TENNESSEE DEPARTMENT OF TRANSPORTATION
EROSION PREVENTION/SEDIMENT CONTROL
INSPECTION REPORT

DATE: 2.16.12

State Route (SR) / US Route or Road Name and Description: Wolf River Blvd.			Are corrective actions required by this inspection report (Y/N): *		
County(ies): Shelby	TDOT PIN: 101615	NPDES Permit (NOC) #: TNR153299	Number of New Corrective Actions: 0	Number of Recurring Corrective Actions: 0	Number of New Sediment Releases: 0
TDOT Construction No.: 7994-1535-54	TDOT Contract No.:	Contractor: Acuff Enterprises Inc.

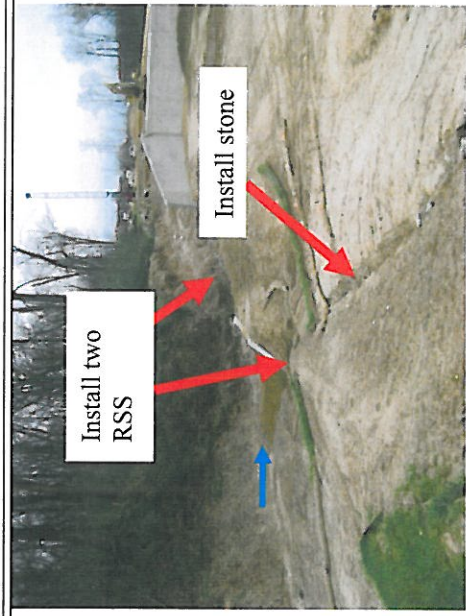
* 108+37	2	North side of WRB	LT	2/13/2012		19,22	FM,W	Daily cleaning will be required, until further notice.
	1	23+00 - 26+00	RT	9/29/2011	T = 10-6-11	33,41	S,W	Temp. stable.
	1	25+00	RT	2/13/2012		15,33,35	FM,W	Remove sediment around existing trees in existing wetland. See photo

Sta. 25+00 RT
Remove sediment around existing trees in existing wetland. (FM, W)

Outfall 10A & 10B Sta. 85+00 RT
Areas need to be temp. stabilized. (FM, W)

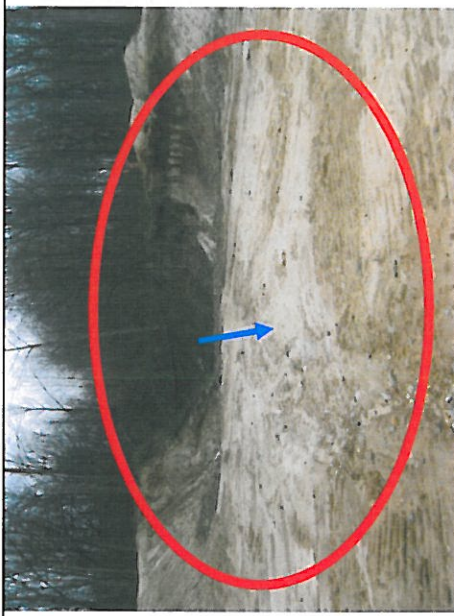
Outfall 11A Sta. 92+50 RT
Areas need to be temp. stabilized. (FM, W)
